Commonwealth Edison
 One First National Plaza, Chicago, Illinois
 Address Reply to: Post Office Box 767
 Chicago, Illinois 60690

December 31, 1981

Subject: Byron Station Units 1 and 2
 Braidwood Station Units 1 and 2
 Advance FSAR Information
NRC Docket Nos. 50-454/455/456/457

This is to provide advance copies of information which will be included in the Byron/Braidwood FSAR in the next amendment. Attachment A to this letter lists the information enclosed.

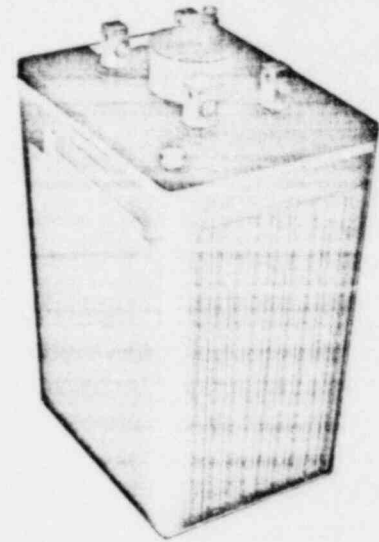
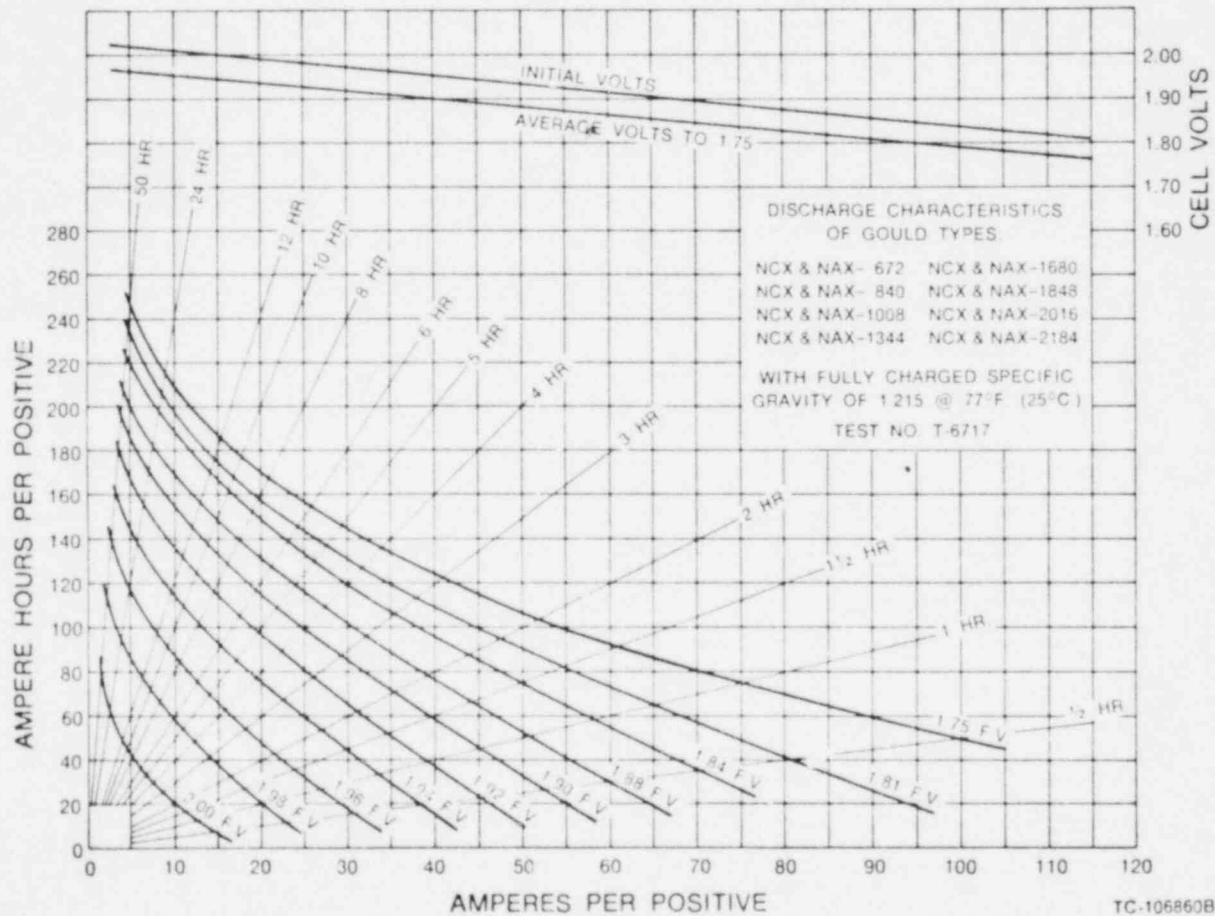
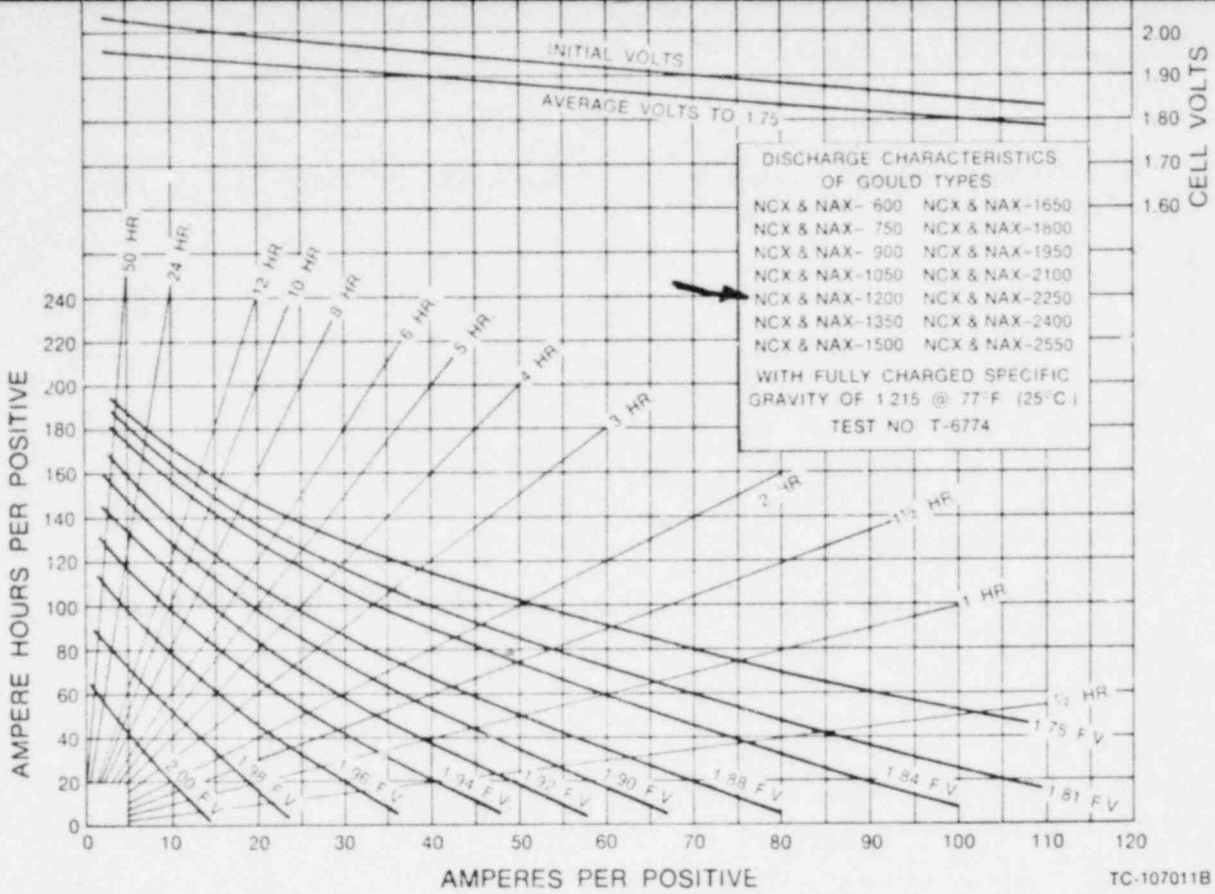
"The response to Q040.69 is incomplete. Provide the ampere-hour rating of each 125V dc battery and the KVA output rating of the battery charger."

1. Each of the (two/unit) 125-V Class 1E batteries consists of 58 Gould Type NCX-1200 lead-calcium cells. The (nominally 1,200 AH) discharge characteristics, and other specifications for these cells are shown on the attached Gould Catalog Sheets (2).
2. Battery capacity is also addressed in Question 040.182.

AUXILIARY AND FUEL HANDLING BUILDINGS
 FIGURE 130.06-2

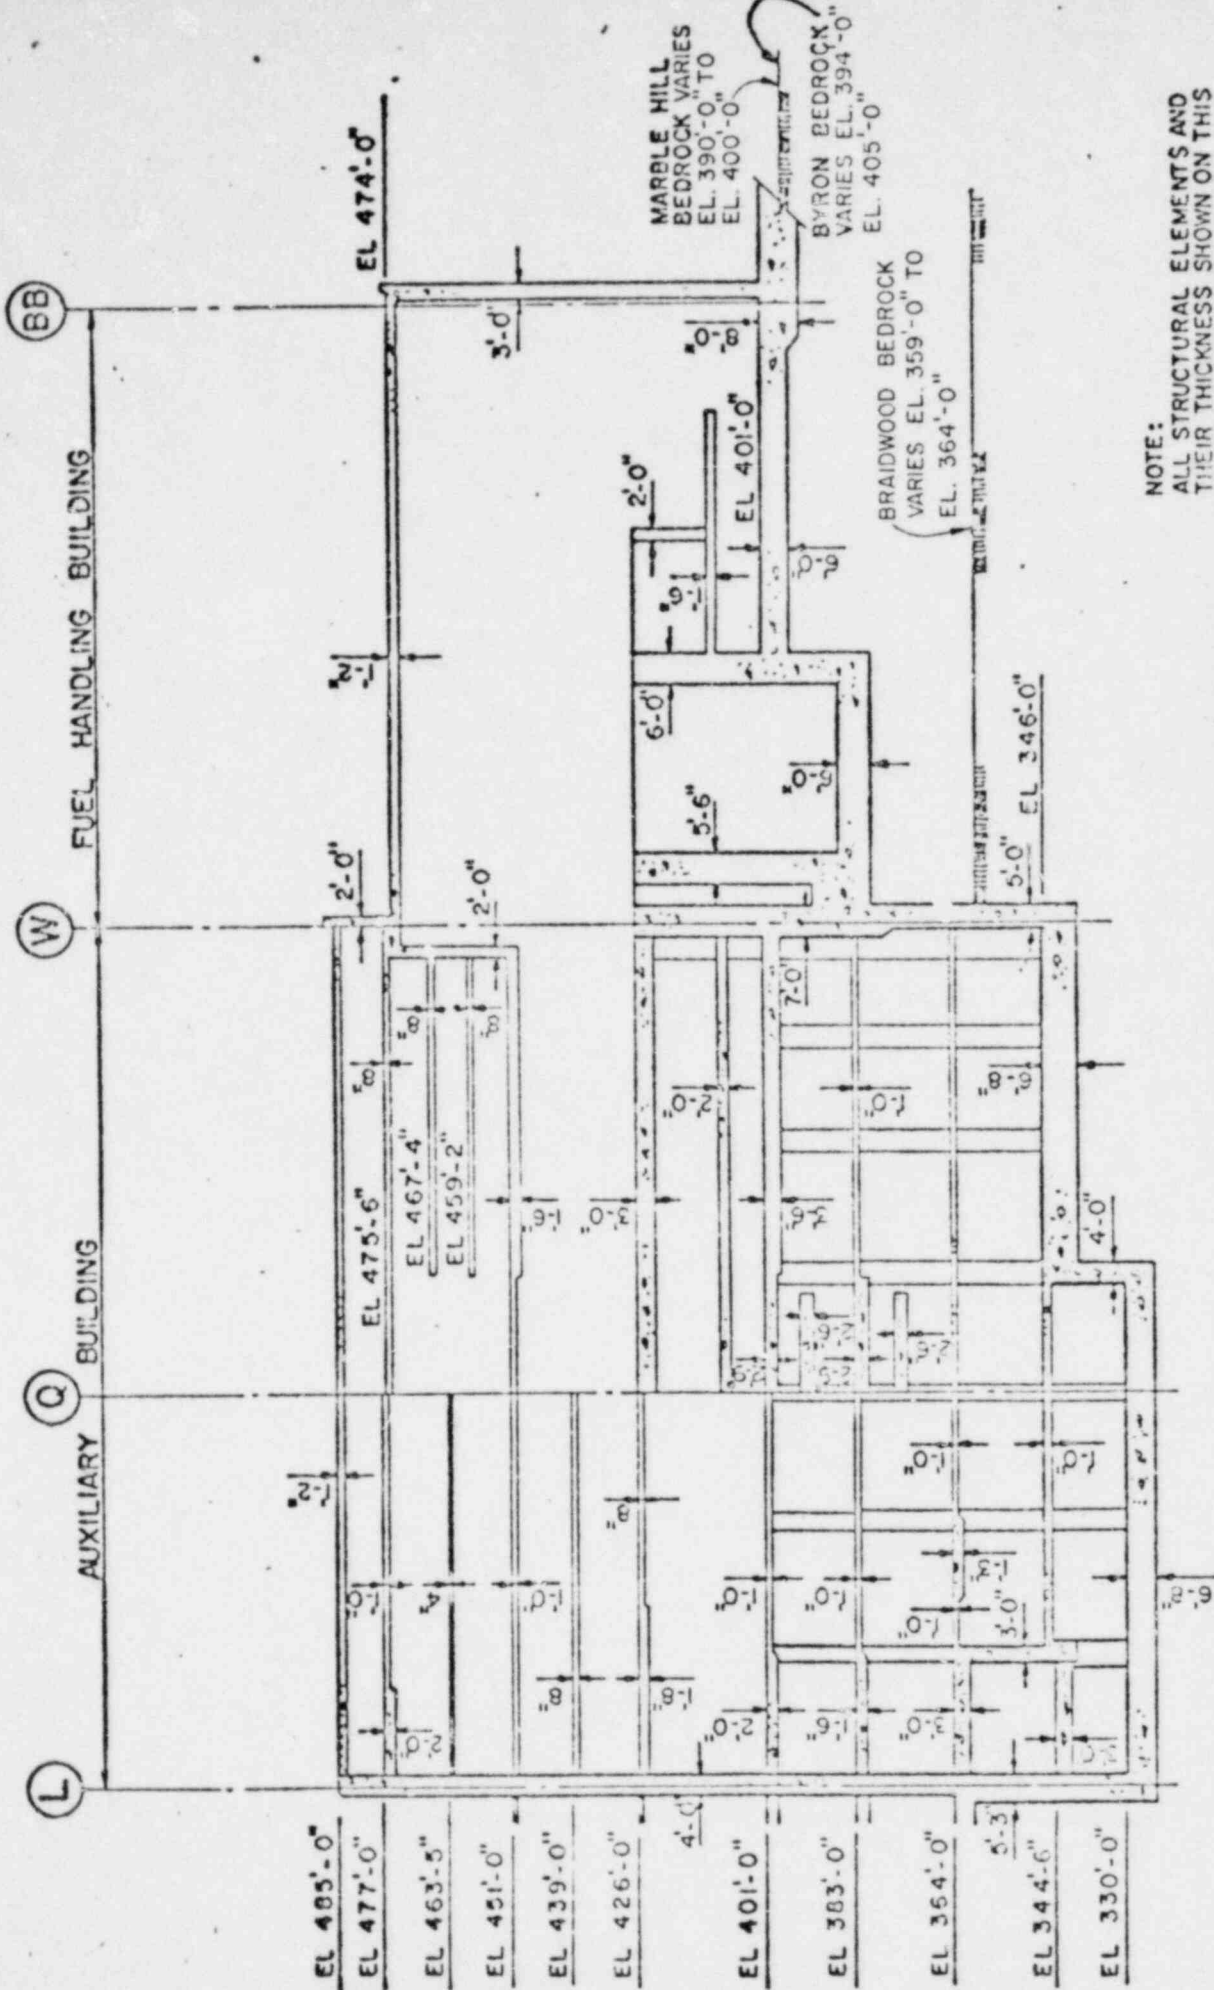
Action Item 4A: Additional information in response to
Question 130.06 (Seismic Reassessment)

5. Figure 130.06-2

Refer to attached Figure 130.06-2 for bedrock elevations.

At the Braidwood site, compacted fill with a minimum relative density of 85% was placed on the glacial till which is at elevation 378'-0". Refer to FSAR Figure 2.5-76 Section 2-2.
